ACIS Verification Summary Report

Requirement Number/Title:	3.3.1.1.1.3 ACIS DA Thermal Interfaces (VRSD 3.3.1.1.1.3)
----------------------------------	---

**AXAF-I
Verification
Requirement
Compliance Data
Submittal**

ACIS Hot Case Analysis Results

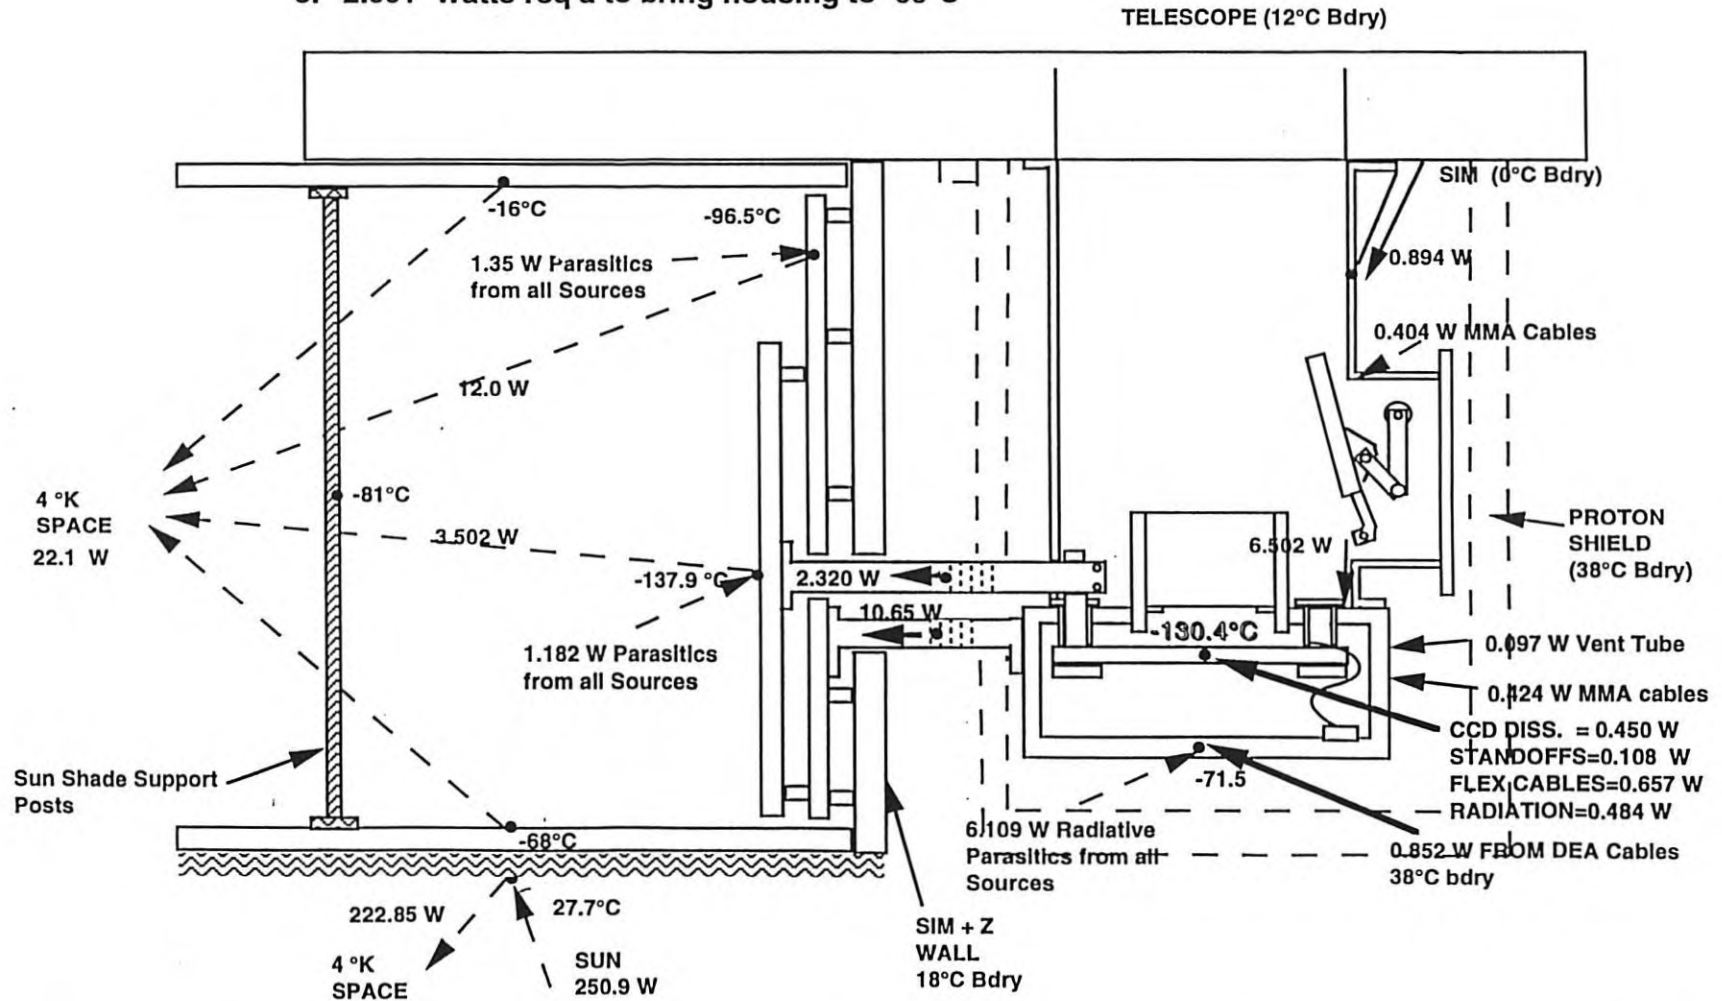
The Verification Summary Report (38-01520.013) states that the requirement is met by calculating focal plane heat loss to ISIM. I interpret the requirement to be specifically the Interface conductance between the ACIS collimator and the SIM translation table. A review of the CDA thermal math model reveals that the linear conduction assumed between the collimator and the translation table to be ~0.02 W/C per attach point (or 0.08 W/C total), which is greater than the 0.05 W/C requirement. However, the analysis should take the most conservative number within the specification which would be assuming 0.05 W/C. Anything higher is only more conservative.

6/23/97 - Updated response received by LMAC. The 0.05 number is outdated. The current ISIM modelling has the most up-to-date calculation of the ACIS collimator to Translation Table thermal conductance. The range is 0.05 W/C for hot case to 0.043 W/C for cold case. By letter of the law, the cold case should use 0.05 W/C, but since ICD is outdated and both "sides" of interface (i.e., BASD and LMAC) are using same numbers, I am approving this verification item.

I agree with John in that if all parties agree with the cold case conductance at 0.043, then that is what we should do. However, we should get a PIRN out to correct the ICD.
